U.S. ARMY CORPS  
OF ENGINEERS

VALUE ENGINEERING STUDY

**SOUTHEAST LOUISIANA  
FLOOD CONTROL,  
ORLEANS PARISH, LA**

**DRAFT REPORT**

DRAWING NO. 2

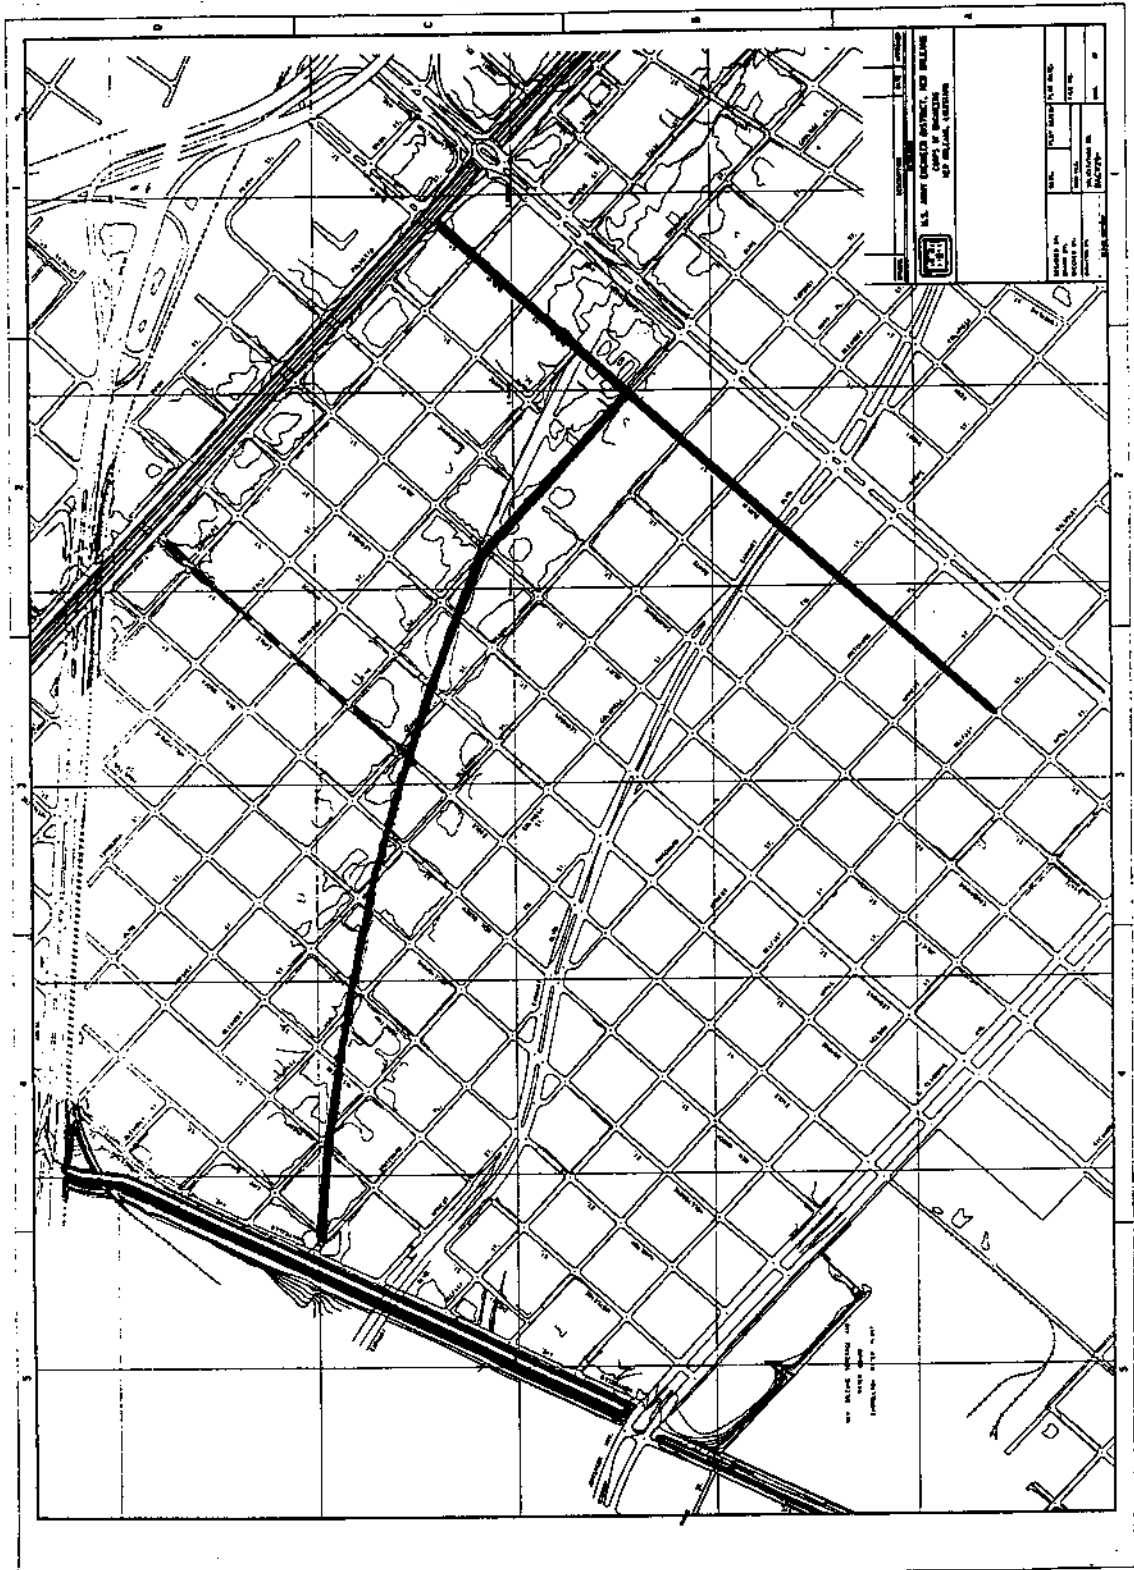
(See Drawing No. 2.) Install a culvert system along Olive Street from Dublin to Joliet. At Joliet, continue along the abandoned railroad right-of-way to Monticello. Locate additional pump station for the two new pumps at Monticello (Prichard and Live Oak, on the end of the railroad right-of-way). Pressure outfall will extend under Monticello and over the floodwall into 17th Street Canal.

DRAWING NO. 1

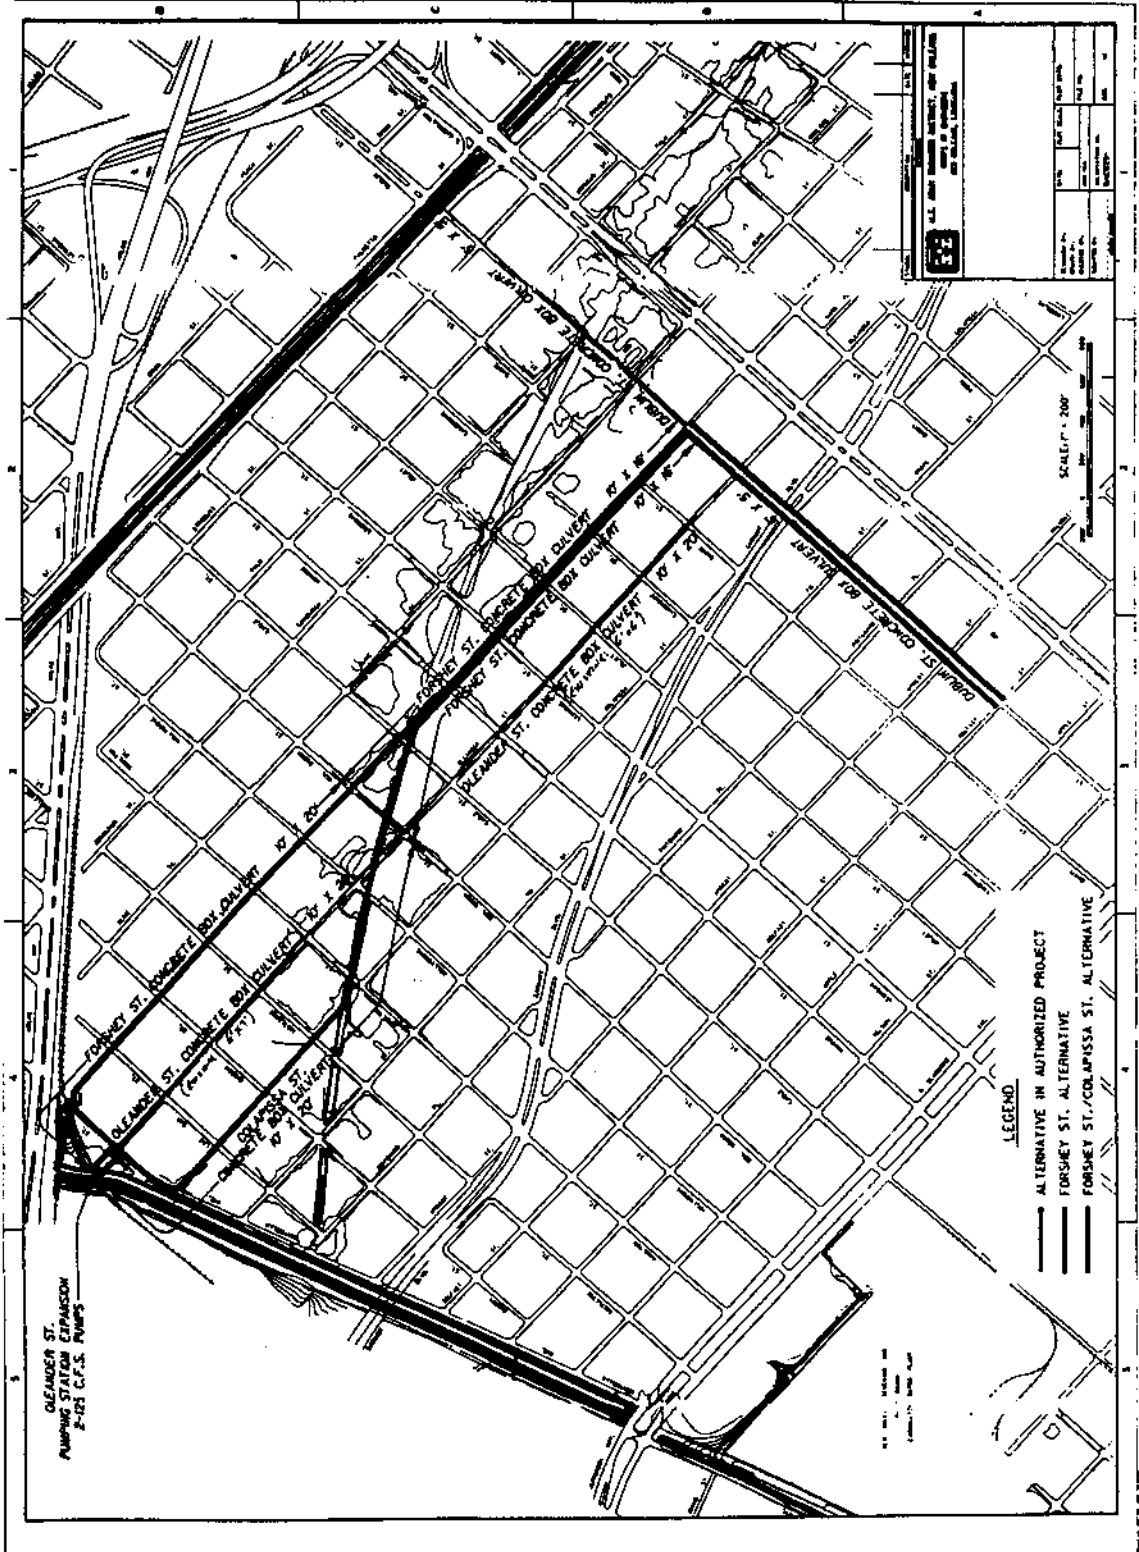
(See Drawing No. 1.) The current design considers several proposed alignments from Dublin to Oleander Pump Station, along Forshey, Oleander or Colapissa. Construction involves excavating existing streets, relocating utilities, installing larger box culverts and adding two additional pumps at the existing Oleander Pump Station

DRAWING NO. 2

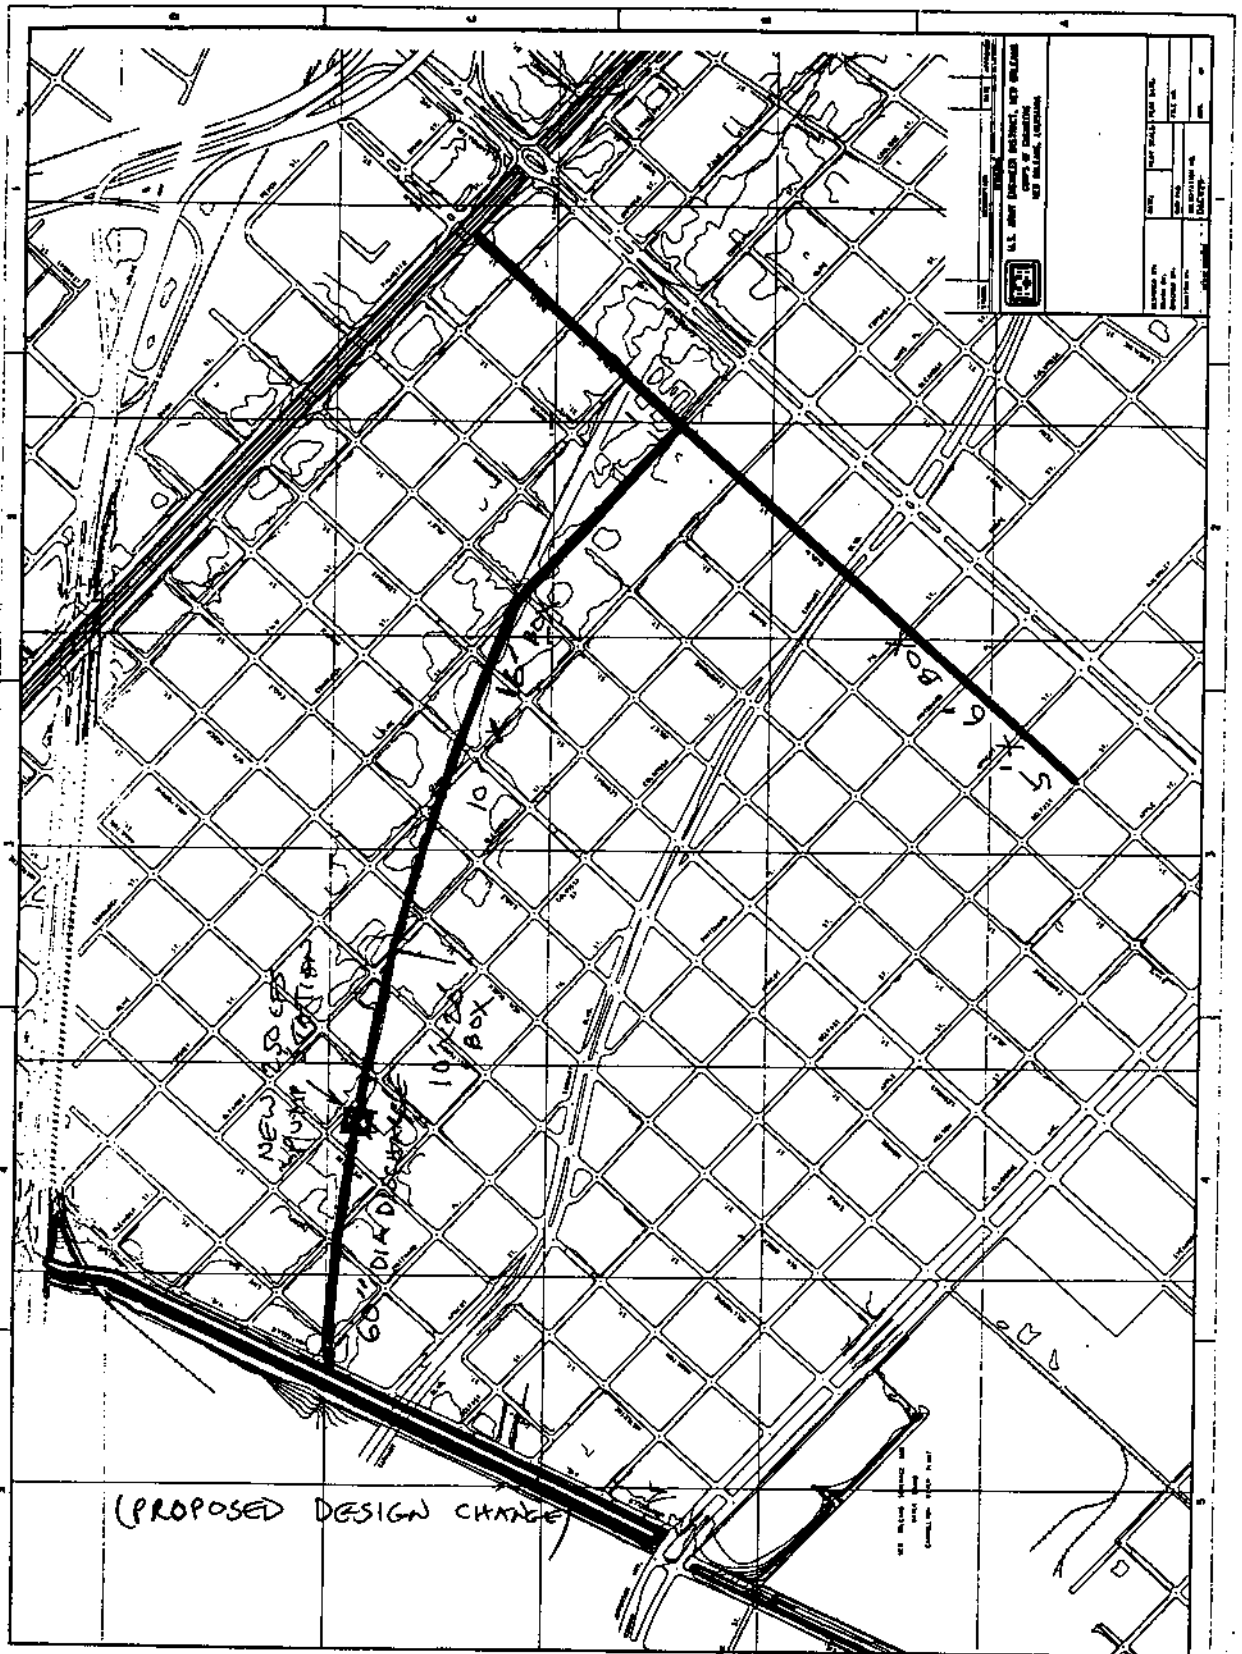
(See Drawing No. 2.) Install a culvert system along Olive Street from Dublin to Joliet. At Joliet, continue along the abandoned railroad right-of-way to Monticello. Locate additional pump station for the two new pumps near Colapissa Street (in the railroad right-of-way). This would allow a single 60" diameter outfall pipe to the Monticello Canal.

DRAWING NO. 1

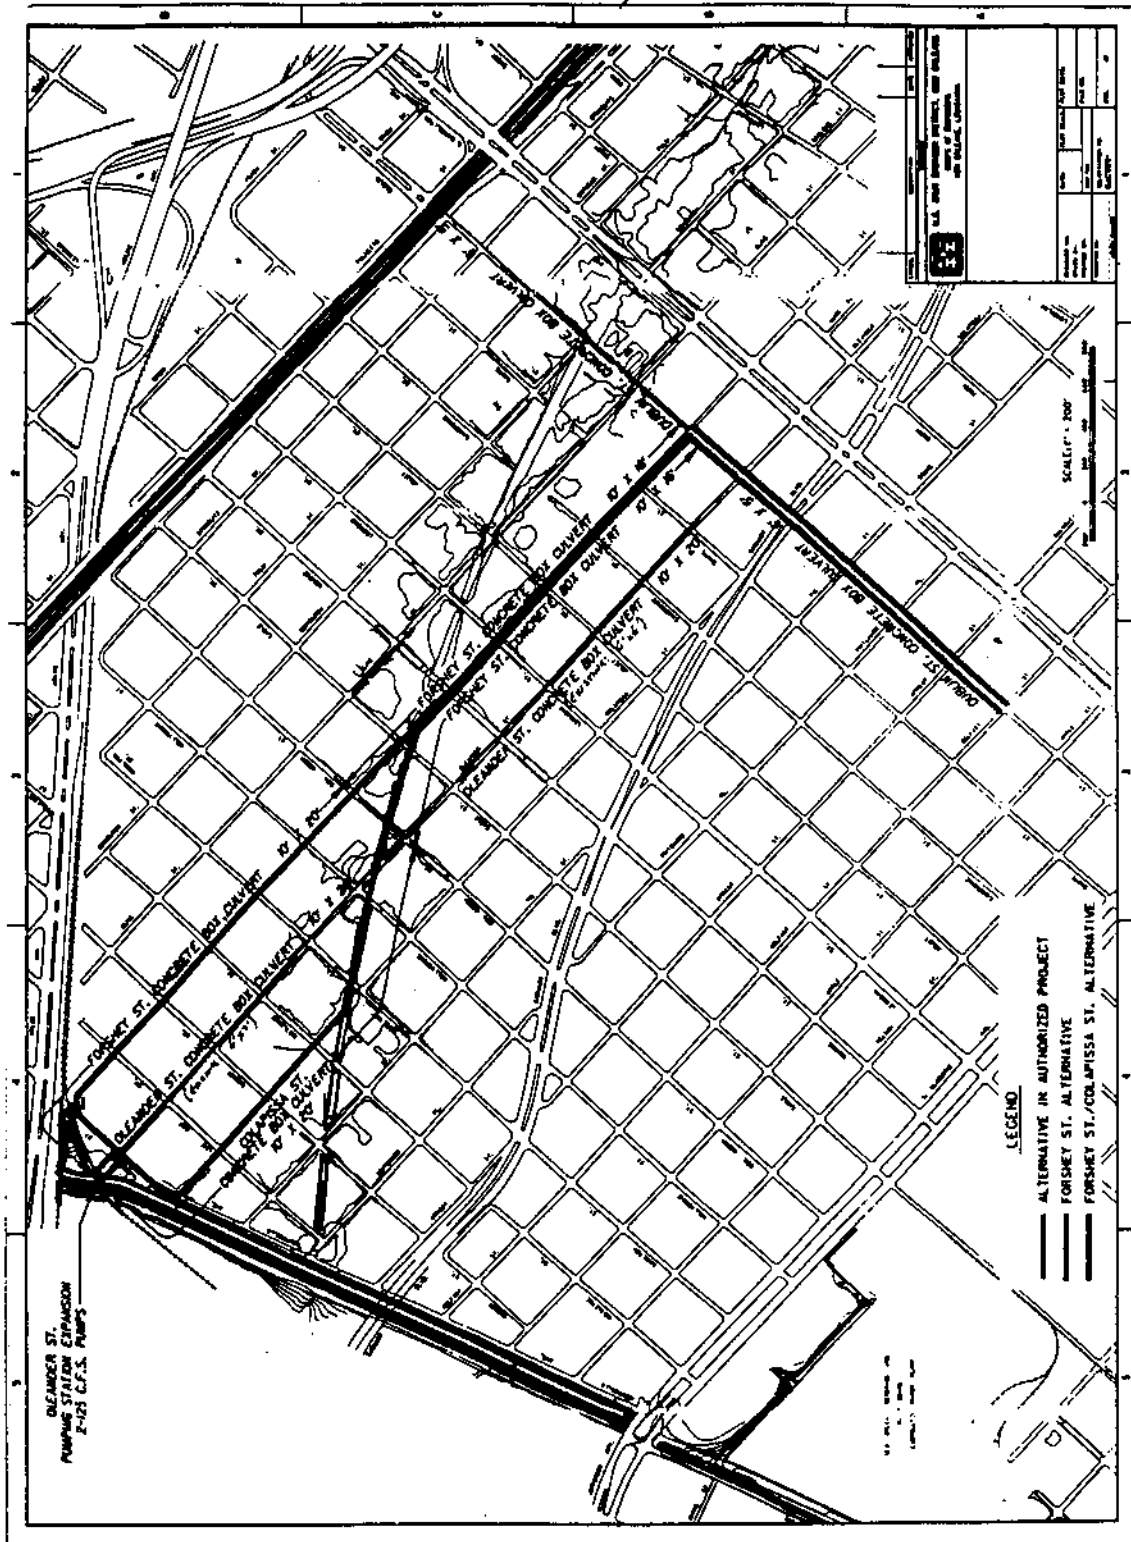
(See Drawings Nos. 1 and 2.) The current design depicts three alternative alignments for this project -- the Oleander Street alignment, the Forshey Street alignment, and the Forshey/Colapissa Street alignment. Drawing No. 2 depicts about a 50% culvert fill. The series of proposals that follows (3A through 3D) optimizes the culvert sizes to flow full under the 10-year event considering cast-in-place or pre-cast culverts applied to the Oleander and Forshey Street alignments. The Forshey Street/Colapissa Street alignment was considered and proven unfeasible.
